SUBJECT: RESTART OF R. E. GINNA NUCLEAR POWER PLANT

TECHNICAL SPECIFICATION CHANGES - REACTOR COOLANT
SYSTEM IODINE ACTIVITY

AMENDMENT TO PROVISIONAL OPERATING LICENSE

Amendment No. 5T
License No. DPR-18

Figure 3.1.4-1

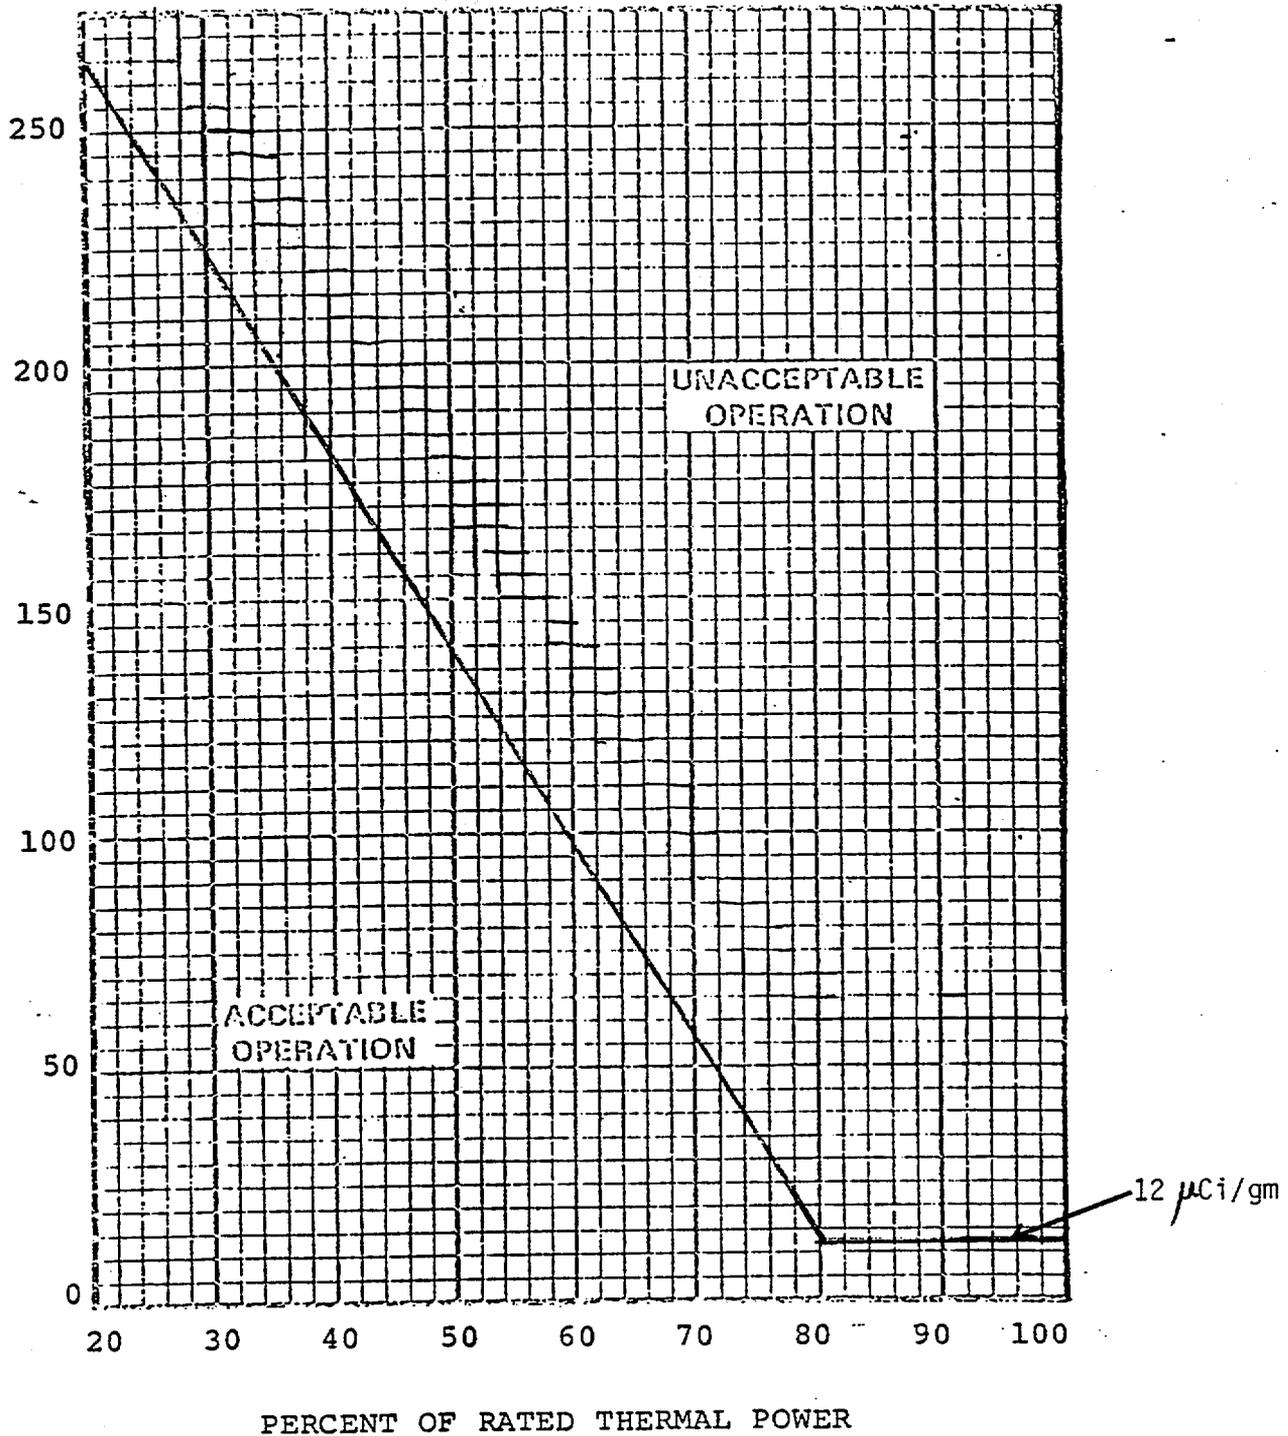
- 3.1.4.2 If the limit of 3.1.4.1.a is exceeded, then be subcritical with reactor coolant average temperature less than 500°F within 8 hours.
- 3.1.4.3 a. If the I-131 equivalent activity in the reactor coolant exceeds the limit of 3.1.4.1.b but is less than the allowable limit shown on Figure 3.1.4-1, operation may continue for up to 168 hours provided that the cumulative operating time under these circumstances does not exceed 800 hours in any consecutive 12-month period. If the I-131 equivalent activity in the reactor coolant exceeds the limit of 3.1.4.1.b for more than 500 hours in any consecutive 6-month period,

- b. If the I-131 equivalent activity exceeds the limit of 3.1.4.1.b for more than 168 hours during one continuous time interval or exceeds the limit shown on Figure 3.1.4-1, be subcritical with reactor coolant average temperature less than 500°F within 8 hours.
- c. If the I-131 equivalent activity exceeds the limit of 3.1.4.1.b, then perform sampling and analysis as required by Table 4.1-4, item 4a, until the activity is reduced to less than the limit of 3.1.4.1.b.
